ग्रिड कंट्रोलर ऑफ इंडिया लिमिटेड  
(भारत सरकार का उद्यम)  
**GRID CONTROLLER OF INDIA LIMITED**  
(A Government of India Enterprise)

**विषय:** Draft Central Electricity Regulatory Commission (Terms and Conditions of Tariff) Regulations, 2024 for the tariff period from 1.4.2024 to 31.3.2029.

**Suggestions on behalf of Regional Load Despatch Centres (RLDCs) and National Load Despatch Centre (NLDC) on CERC Terms and Conditions of Tariff Regulation-2024**

Fig-1

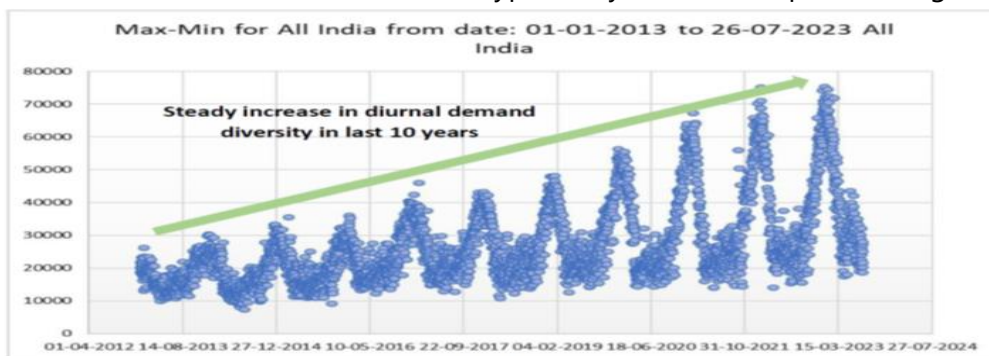
a) As large scale RE will keep on integrating into the grid, the thermal fleet has to complement to the variability being introduced by RE into grid. The diurnal variation of demand has also increased steeply. The diurnal variation of demand for the period 01.01.2013 to 26.07.2023 is shown in Figure 1. The variation in the diurnal demand has resulted into high ramping requirement during morning and evening peak hours. The variation in the diurnal demand for a typical day has been depicted in Figure 2.

**Fig-3**

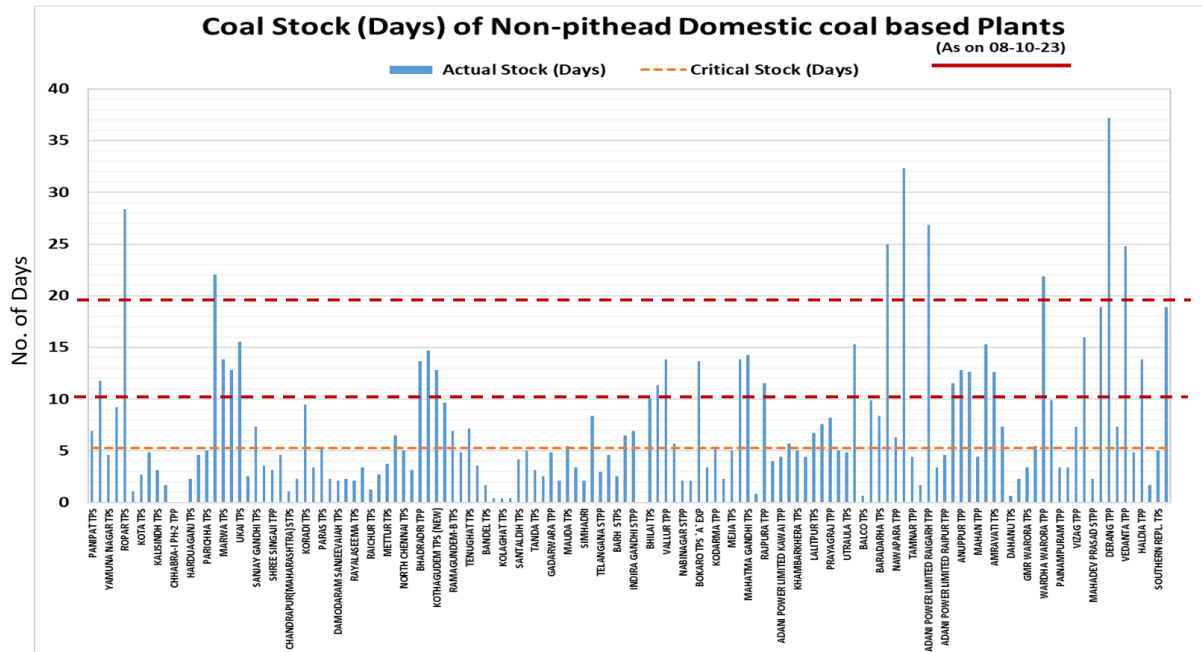
- a) Draft regulation has allowed Generators interest on working capital corresponding to different fuel stock circumstances.
- b) The availability of generators is calculated on a day ahead basis, which doesn't truly capture the on-site fuel stock position. It has been observed that during real time operation generators are declaring full availability for the day but not maintaining enough fuel stock as required under the Regulations. This becomes evident during the periods of continuous high demand where they are not able to generate on a sustained basis up to the Declared Capacity (DC). Instead, the generators revise the DC in accordance with the provision of IEGC Regulations.
- c) During the high demand period of Oct-2023, it has been observed that only a few non-pit head plants could maintain desired coal stocks, while most of the plants barely

maintained critical coal stock level. The coal stock position of a typical day 08<sup>th</sup> October 2023, is depicted in Figure 3.

**Maintaining adequate fuel stock is necessary for resource adequacy to reliably serve expected demand of the consumers in cost effective manner in all time horizon. Hence it is suggested that the Generator availability may be suitably linked to fuel availability also for fixed cost recovery. For scheduling purposes, the daily availability declaration as per IEGC shall continue to be used.**

**Fig-4**

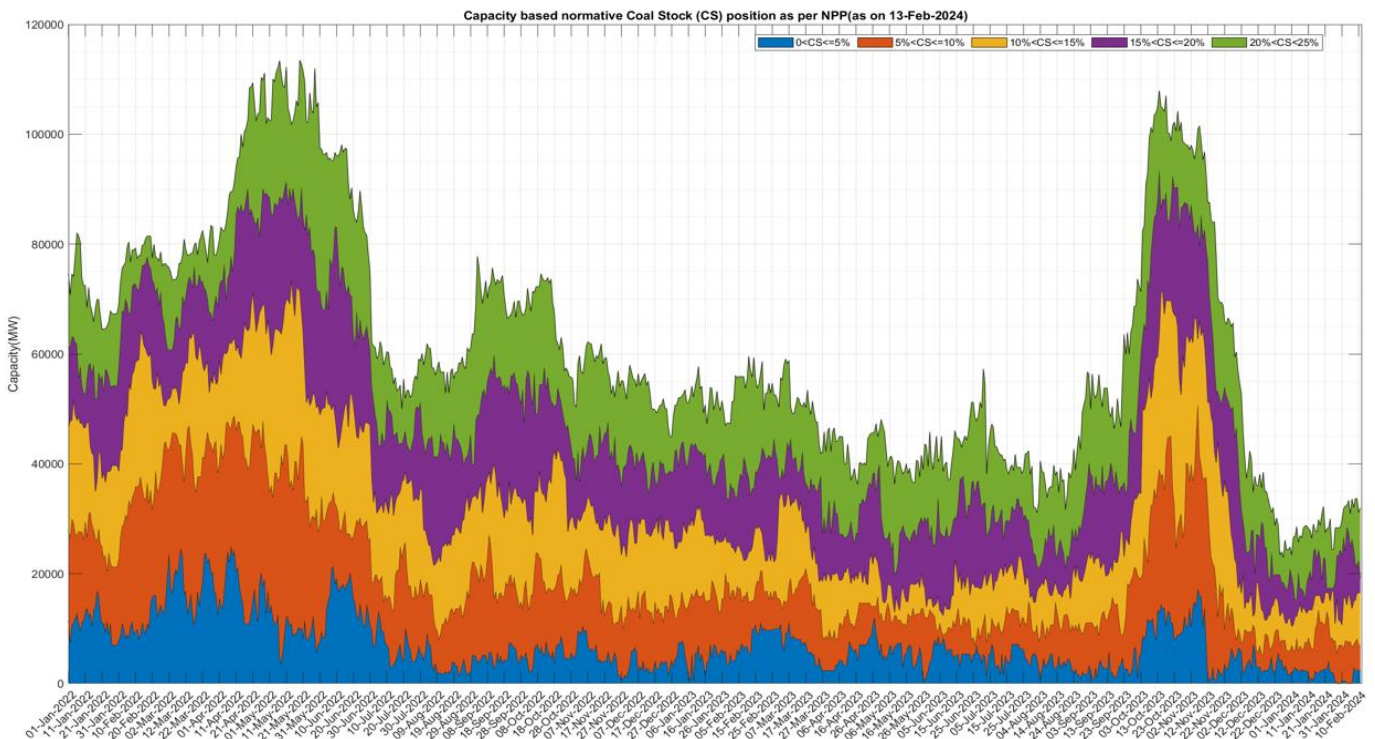
Further, that coal stock position gets severely depleted especially with onset of high demand seasons. The thermal generation capacity under critical coal stock is depicted in Figure 4. It can be seen from the figure that in October 2023, more than 50% capacity of the coal based thermal fleet were having coal stock less than 25% .

**Fig-5**

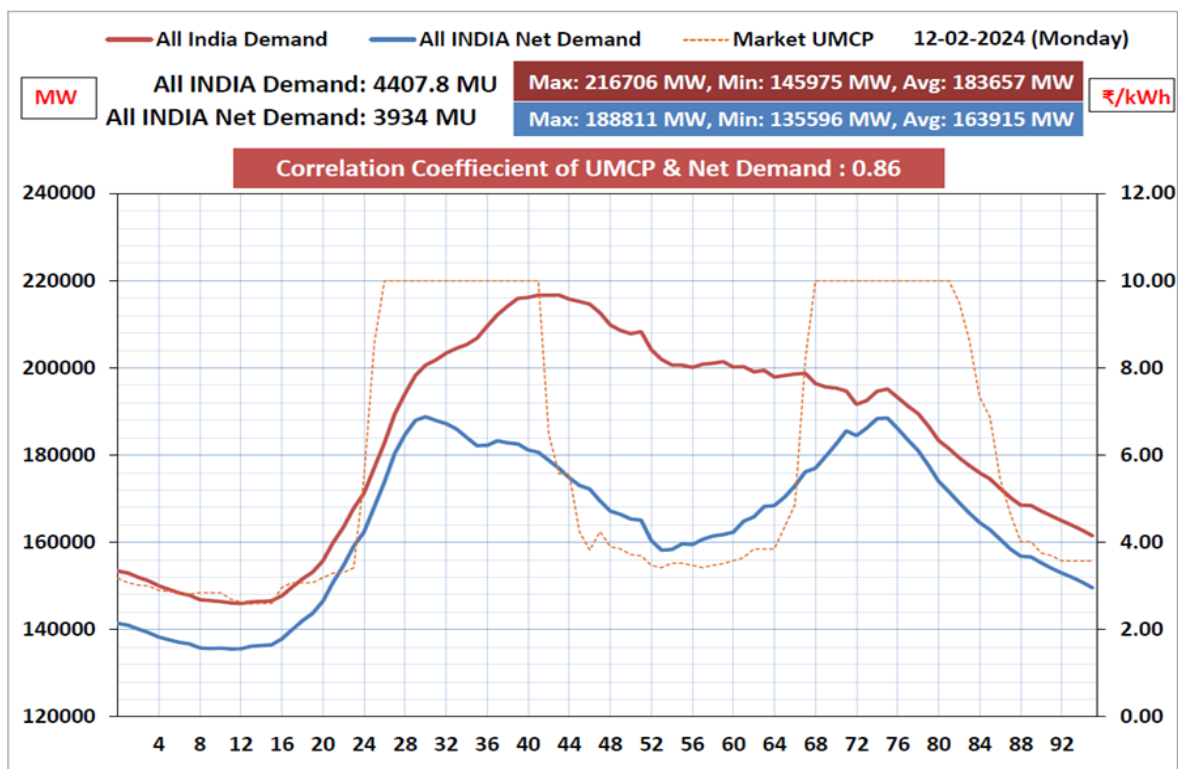
- a) With increasing RE penetration, and shifting of agricultural loads during the solar hours, the shape of the net load (demand less RE generation) has undergone changes in past years. The net load curve of a typical day is depicted in Figure 5.

**Hence, it is suggested that Hon'ble Commission may specify peak hours in such a way which coincides with the hours of Peak All India net load (demand less RE generation).**

Fig-6

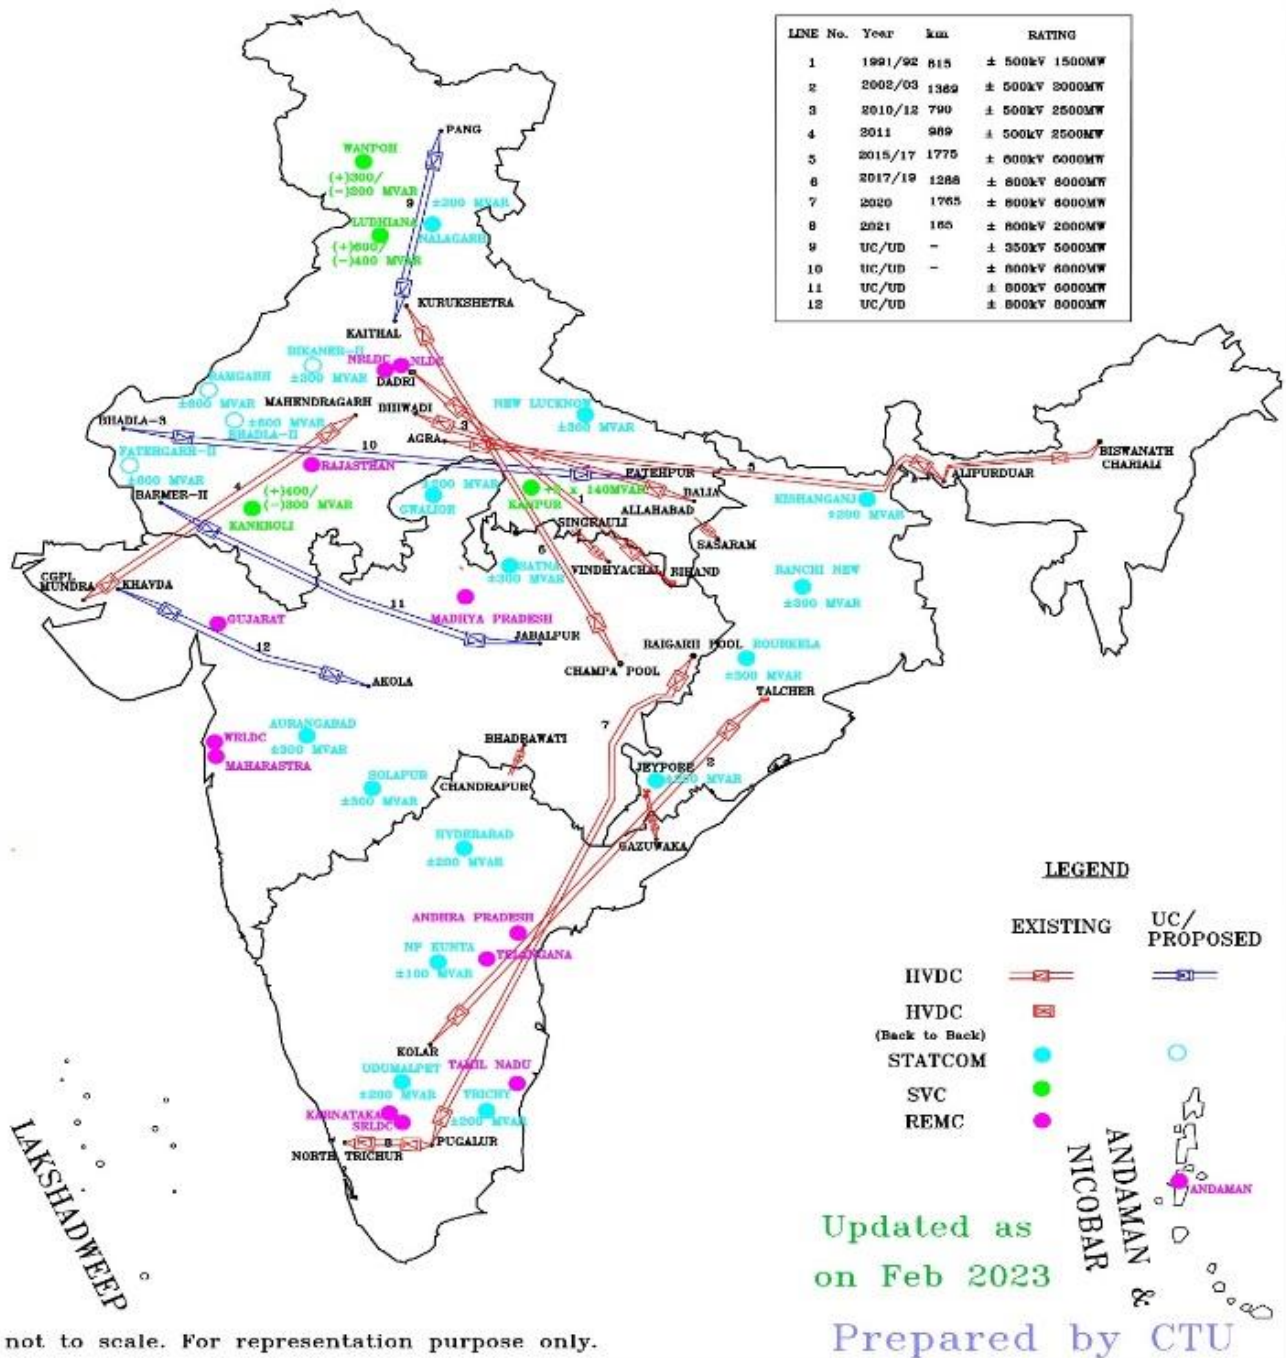
- c) STATCOM being a dynamic VAR compensation device, provides fast reactive support to the grid during transient as well steady state operation. STATCOM has an additional feature of power oscillation damping which need tuning of its settings. In order to analyse the dynamic performance of STATCOM (STATCOM+ MSR /MSC) during day-to-day operation, installation of PMU for measuring the parameters of Coupling Transformer of the STATCOM is essential. In addition to PMUs, high resolution data of the period for faults where STATCOM should operate is also required to be provided by the transmission licensees. In absence of dynamic response data, it becomes difficult to analyse the performance or availability of STATCOM. The details of existing and proposed STATCOM are shown in Figure 6. The list of existing and upcoming STATCOMs is enclosed as Annexure I.

Considering the important role of STATCOMs in grid reliability, STATCOMs and SVCs Normative Annual Transmission System Availability Factor (NATAF) calculation should be separately mentioned in the TCT Regulations suitably.
